**WORCESTER COUNTY TECHNICAL REVIEW COMMITTEE
AGENDA**

**Wednesday, February 11, 2026 at 1:00 p.m.
Worcester County Government Center, Room 1102, One West Market Street,
Snow Hill, Maryland 21863**

A. 9529 Stephen Decatur Highway – Minor Site Plan Review

B. 589 Group Project – Major Site Plan Review

OVERALL SITE DEVELOPMENT PLAN

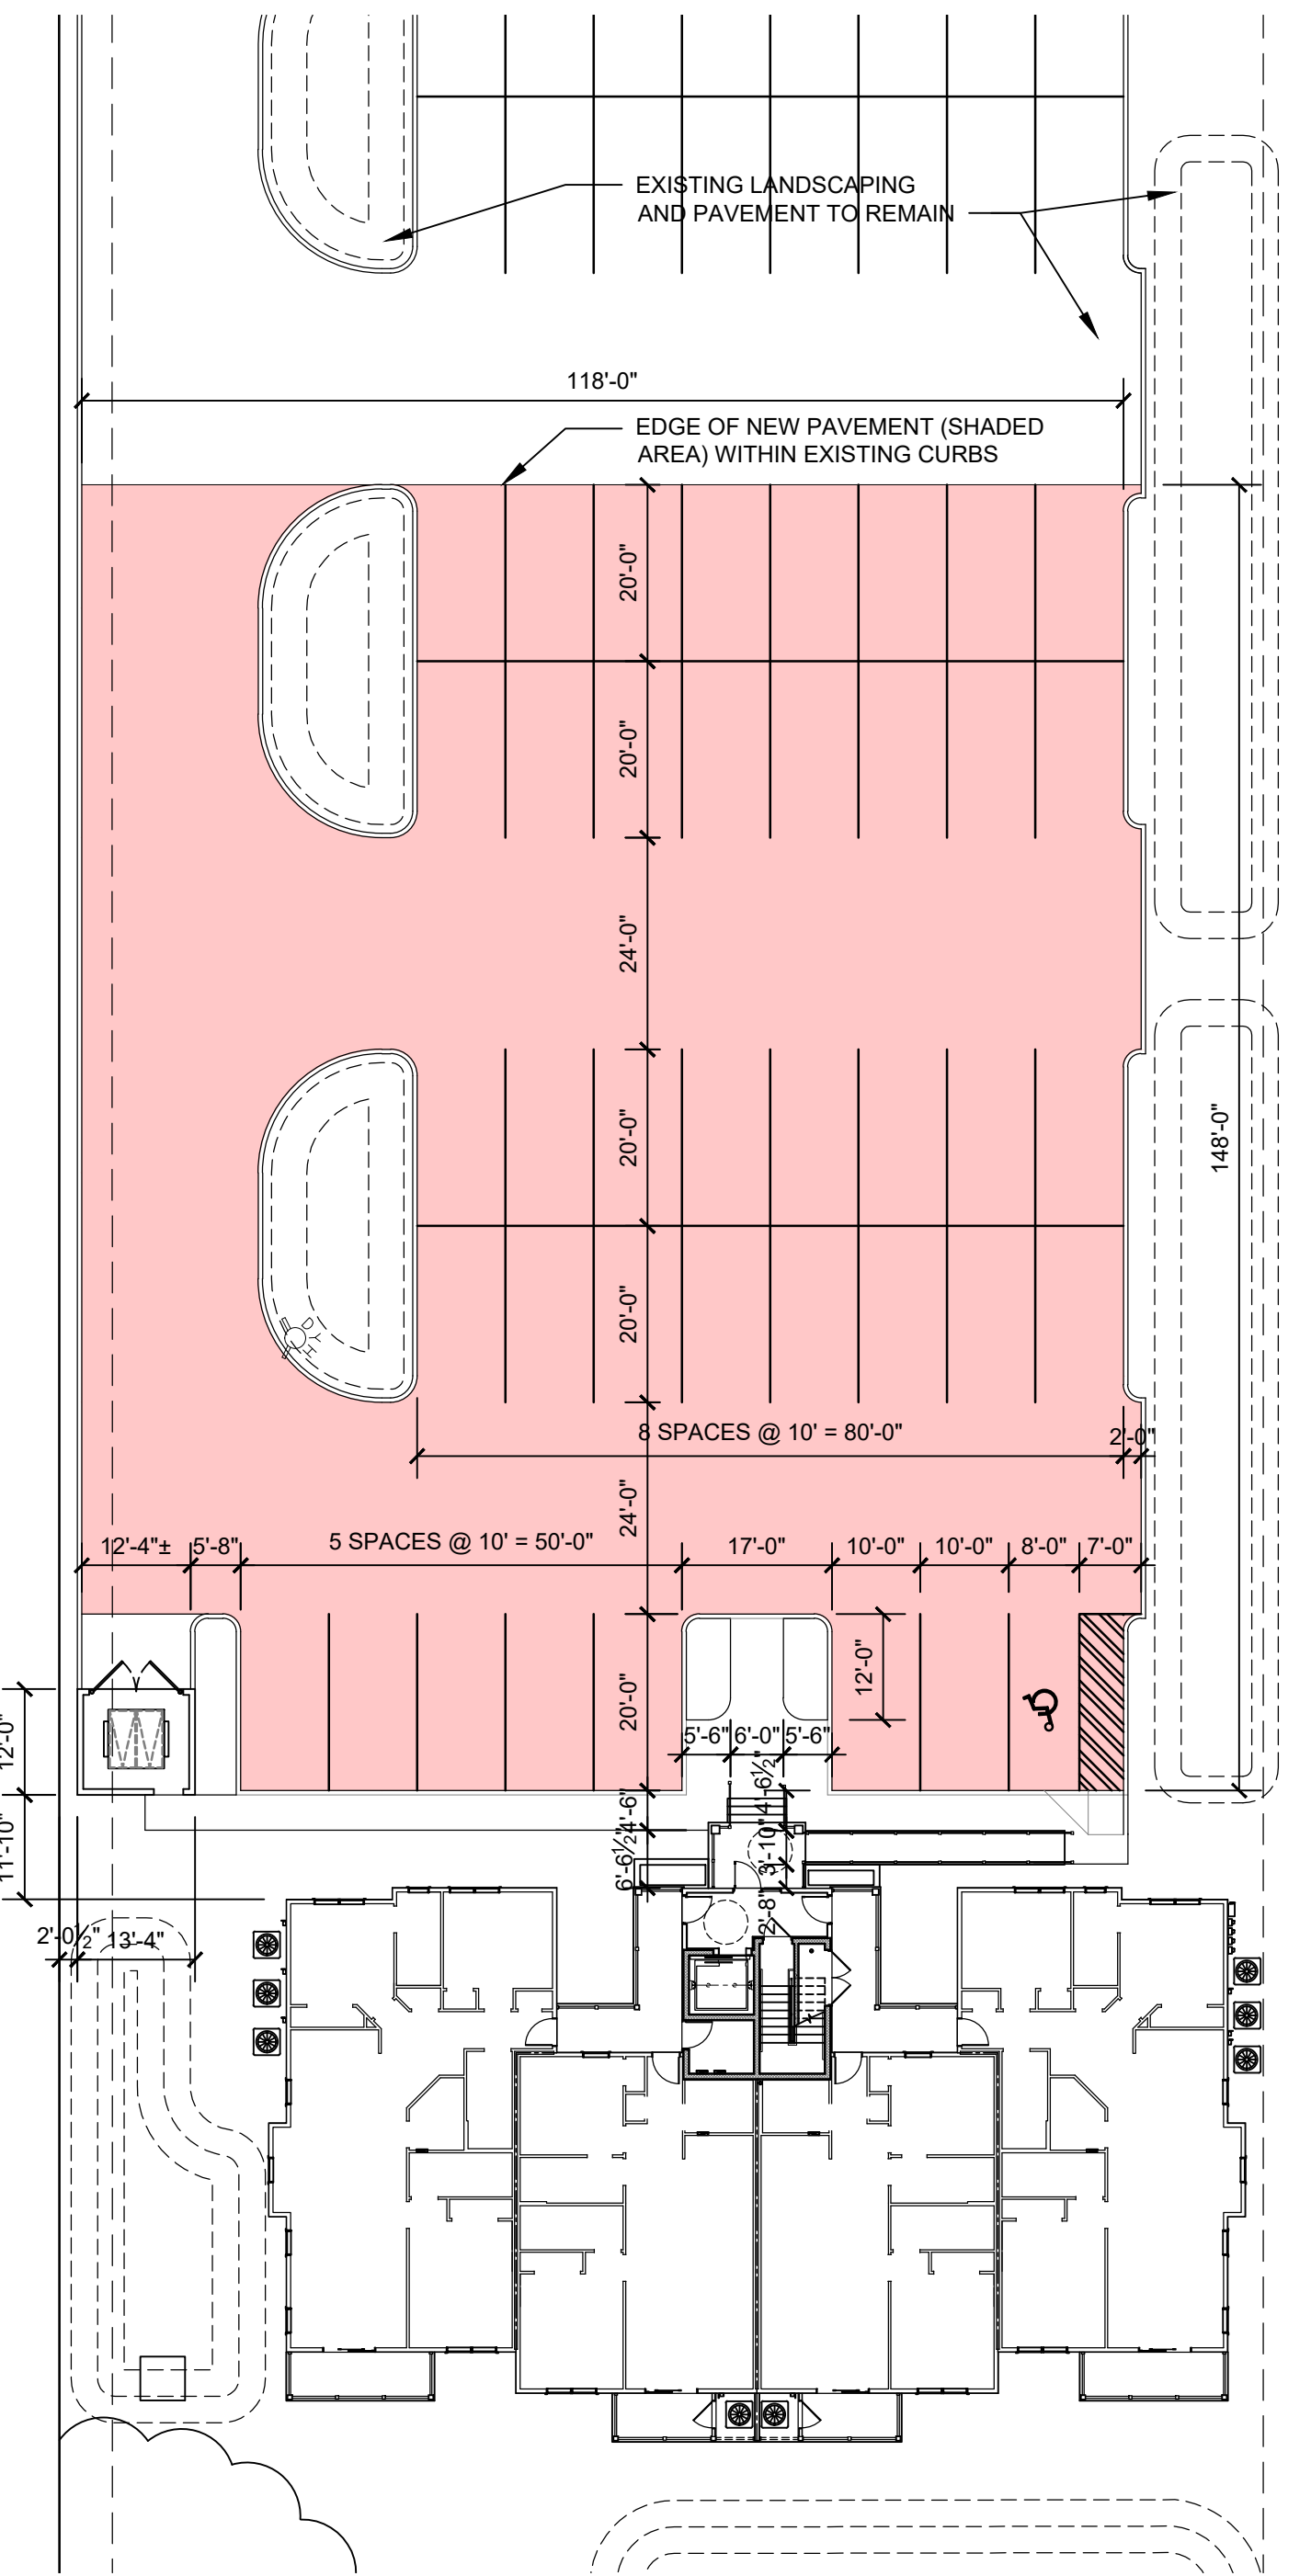
1. Cover Sheet: Please add a note in the project data that the zoning district is C-2 General Commercial.
2. Sheet C200: Please clarify the number of parking spaces that currently exist as well as the number of parking spaces that are proposed.

3. Sheet C200: Please revise the parking tabulation to ensure there are no fractions. Where the calculation of required parking spaces results in a fraction of less than one-half, it shall be disregarded. Any fraction of one-half or more shall be rounded up to the next whole number. §ZS1-320(a). <https://ecode360.com/14021037>.

4. Sheet C200: Please revise the number of required spaces from 99.8 to 103, and please revise the total number of required and provided parking from 124 to 127.

5. Sheet C200: Please clarify the parking spaces shaded in pink. Are these proposed? If so, there are 40 proposed spaces, while the parking tabulation states there are 24 spaces proposed.

7. Sheet C200: Please add adjacent parcel information including tax map and parcel and zoning information.
8. Sheet C200: Please label the sidewalks in the front of the building.

9. Sheet C200: Please clarify if there is any accessibility to the rear of the structure.
10. Sheet C200: Please add a dumpster detail.
11. Sheet C200: Please revise the ADA van-accessible parking space width to 16.' Please also provide typical details for the signage. The height of the ADA sign at installation will be a minimum of 7' from the bottom of the sign to grade.

12. Sheet C200: Please provide one (1) bicycle rack.
13. Sheet C200: Please provide parking bumpers or wheelstops. Parking bumpers or wheelstops shall be at least five inches high and five inches wide, located no less than eighteen inches from the head of the parking space and attached to the parking lot surface. Where parking spaces abut sidewalks, pathways, walls or fences, landscaped areas or public rights-of-way, parking bumpers, wheel stops or curbing shall be located not less than three feet from these features to prevent vehicles from obstructing areas of pedestrian travel or damaging landscaping or structures. §ZS1-320(f)(5).
<https://ecode360.com/14021053>.

14. Sheet C200: Please provide a tabulation of the commercial and residential use areas of the net lot area to ensure that 65% of the parcel is improved with commercial uses.

15. Sheet C200: Please provide plant quantities and icons in the schedule.
16. Sheet C200: Please provide landscaping at the end of each parking row. §ZS1-322(f)(2).
<https://ecode360.com/14021135>.

17. Sheet C200: Each landscaped area must be readily accessible to a water supply. Unless xeriscaping plant material and technologies are employed, all landscaped areas shall provide an automatic irrigation systems with rain sensors. Drip irrigation systems are preferred. If an automatic system is not feasible, the Planning Commission at its discretion may approve an alternate watering system to maintain the plant material. §ZS1-322(b)(7).
<https://ecode360.com/14021089>.
